Agenda Item 3
681 Mayflower Road
Replacement Windows and Doors

STAFF REPORT AND RECOMMENDATION

TO:	Chairman Grinnell and members of the Historic Preservation Commission
DATE:	July 26, 2023
FROM:	Jennifer Baehr, Planner
SUBJECT:	681 Mayflower Road – Window and Door Replacement

TO: Chairman Grinnell and Members of the Historic Preservation Commission
DATE: July 26, 2023
FROM: Jennifer Baehr, Planner
SUBJECT: **845 Maplewood Road**
Demolition, Additions, Alterations and Building Scale Variance

TREE REMOVAL PLAN
CONSERVATION EASEMENT HIGHLIGHTED IN YELLOW

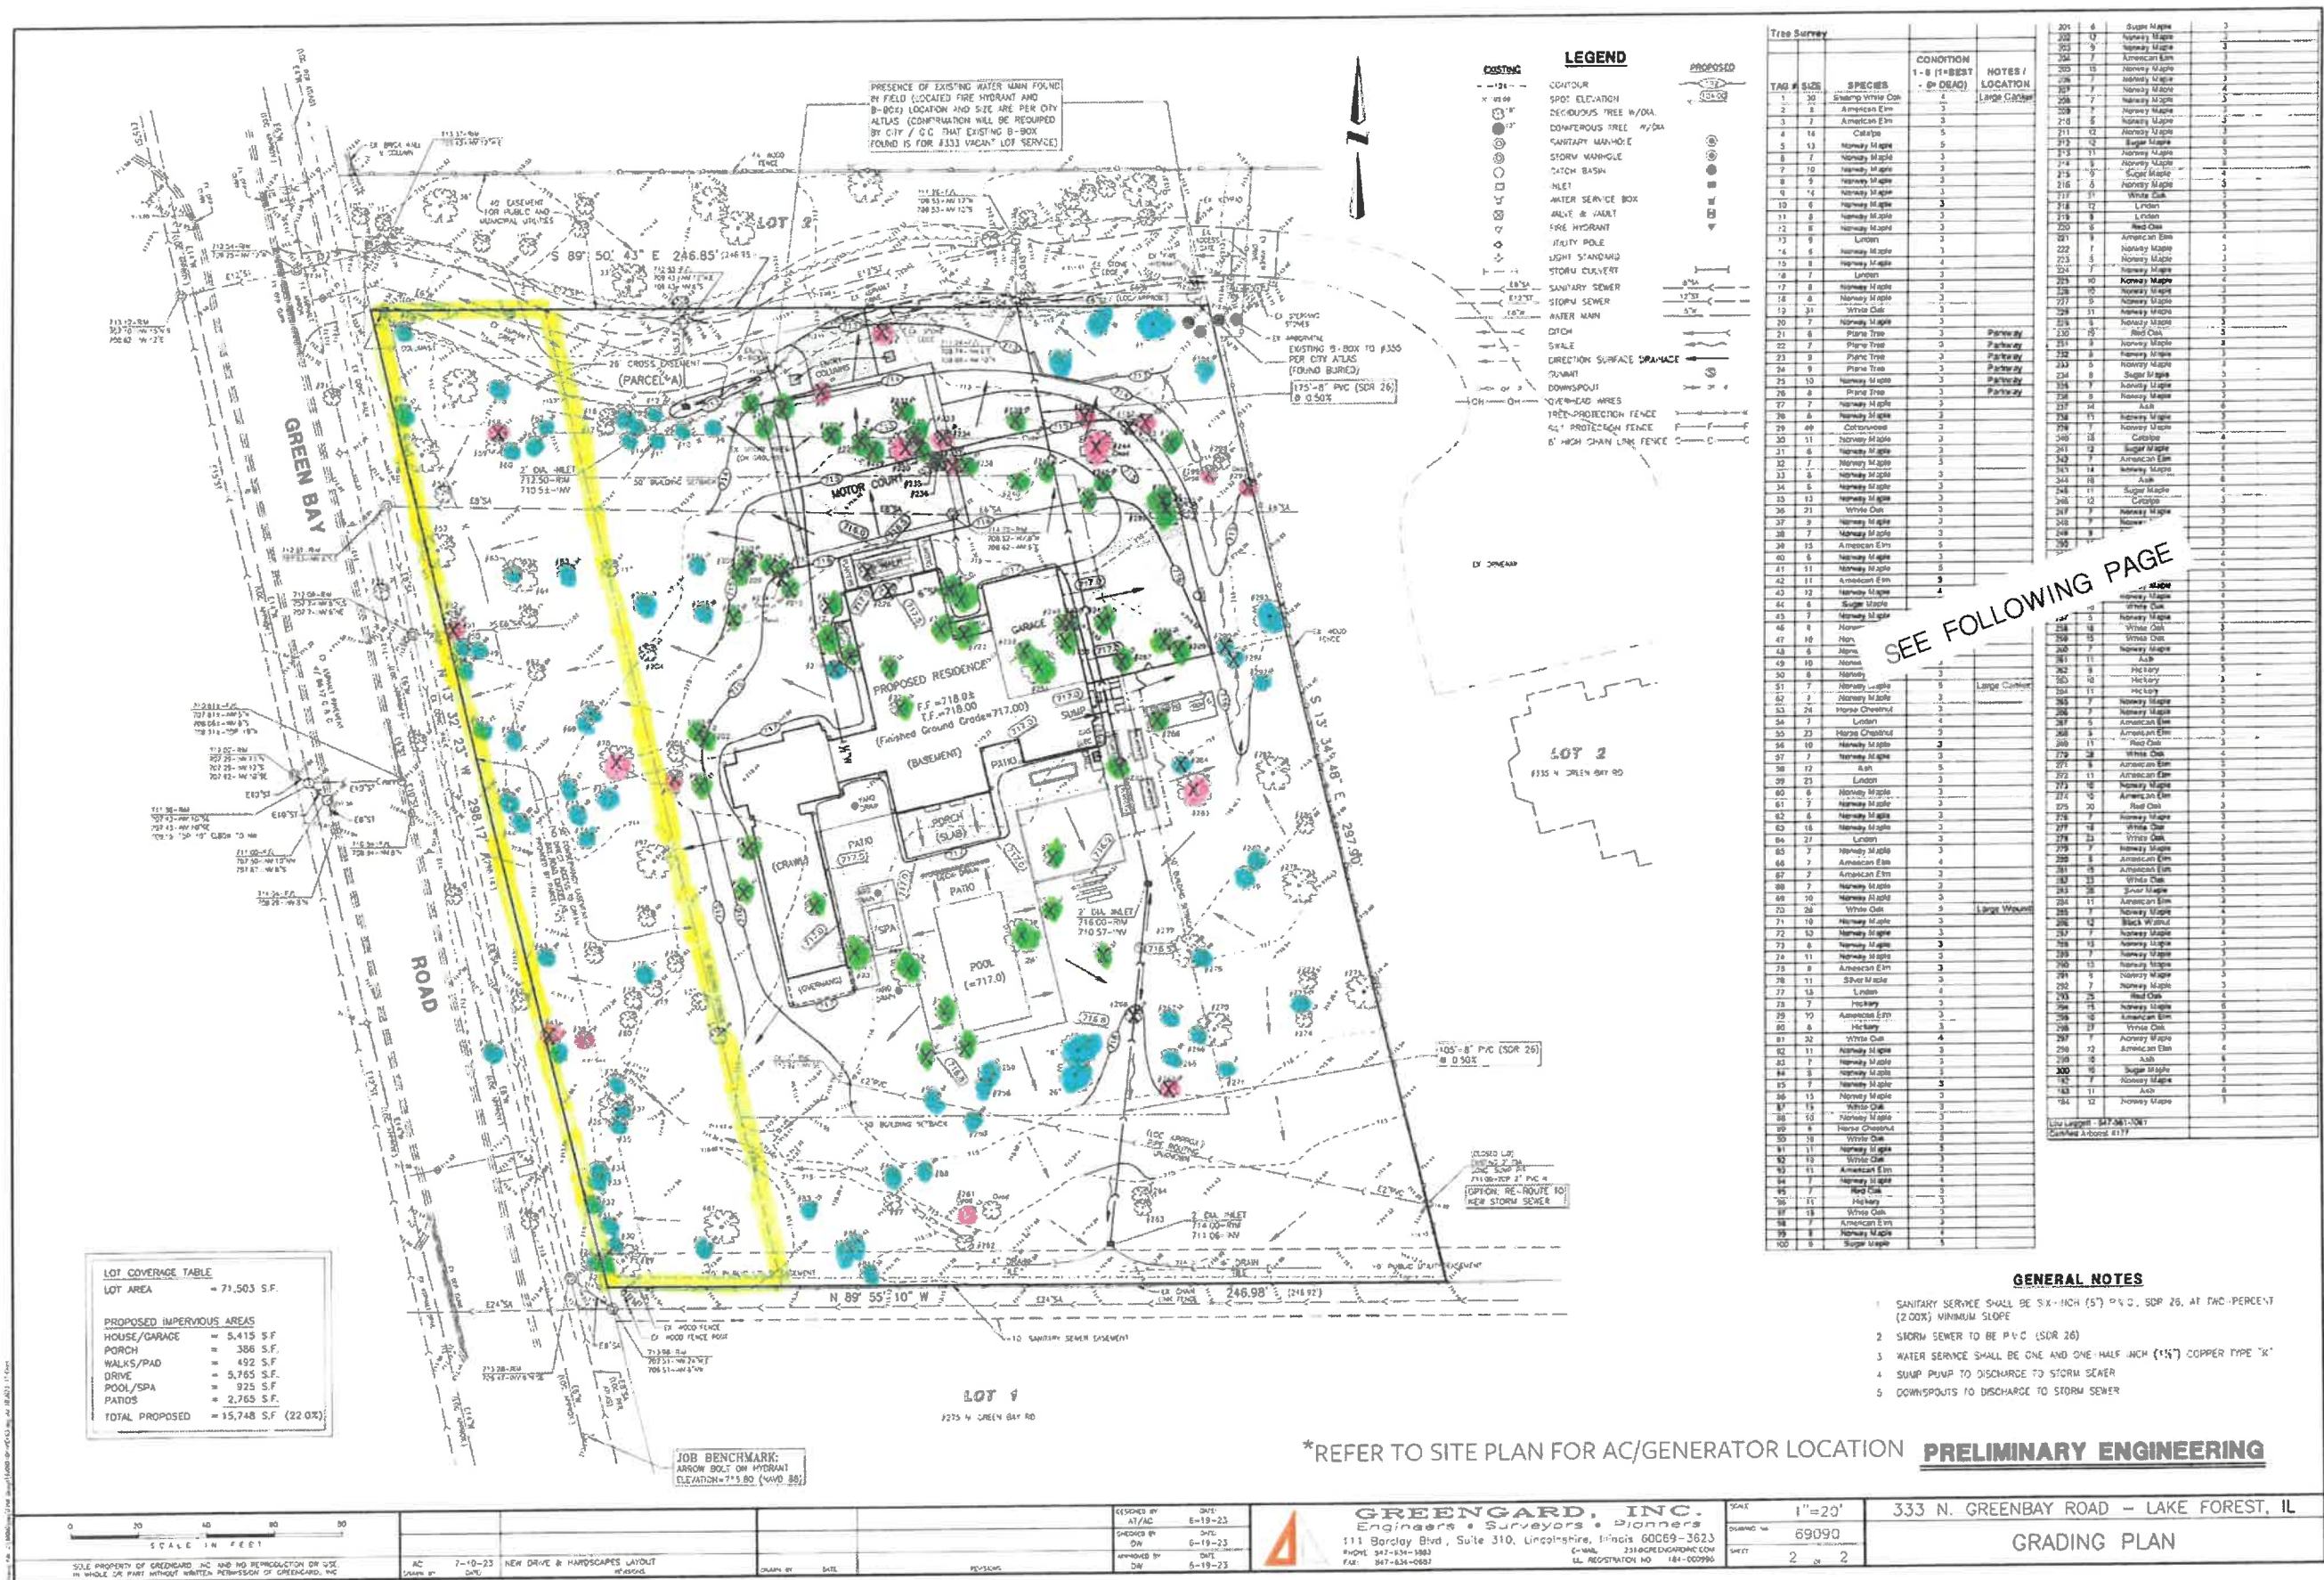
Some of the trees proposed for removal are located in the 50 foot conservation easement on the west side of the property. As noted above, the conservation easement was established to maintain the wooded character along the street. If tree and vegetation removal is proposed in the conservation easement, a detailed replanting plan must be provided that reflects landscaping that provides the same level of density as the current plantings in the easement.

Staff Recommendation: Continued Commission consideration of tree removals proposed beyond those immediately impacted by the proposed construction is recommended along with review of a more detailed, overall landscape plan.

Continue consideration of the tree removal and detailed landscape plan. These plans shall be returned to the Commission for further review and will be subject to Commission approval.

Aluminum Fence : 54" ht.

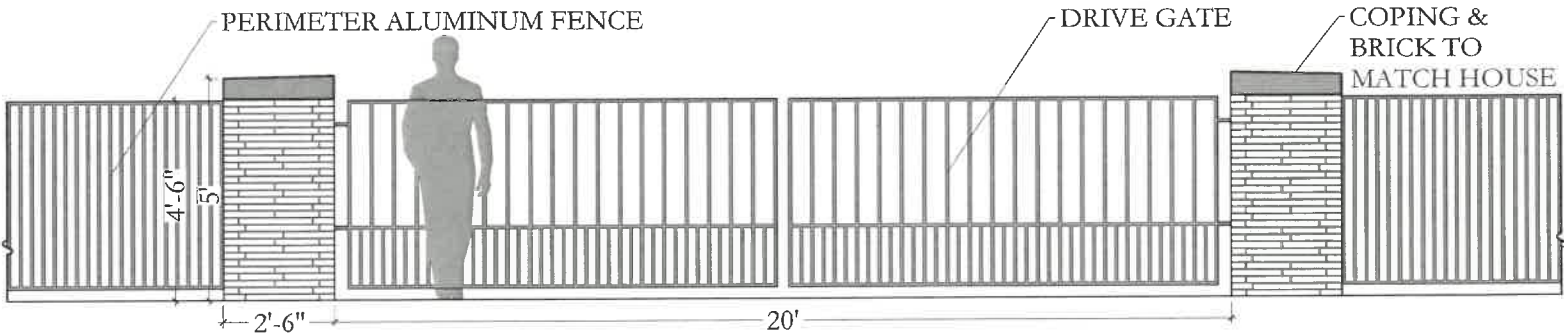
A 4.5 foot tall black, aluminum fence is proposed along Green Bay Road, on the west property line. The Zoning Code permits a fence on the front property line of up to 4 feet. The fence along the front property line will need to be reduced in height to comply with the Code. The aluminum fence is also proposed along the north side of the property and is permitted however, within the Conservation Easement, the fence will need to be at least 80 percent open. A calculation will need to be provided by the petitioner to verify that the fence is at least 80 percent open. An invisible fence is also permitted within the conservation easement. A 6.5 foot tall wood fence is proposed along the south property line and along a portion of the east property line.

1. The location of the fencing must be modified to conform to the zoning regulations and the conservation easement. The fence along the front property line must not exceed four feet.
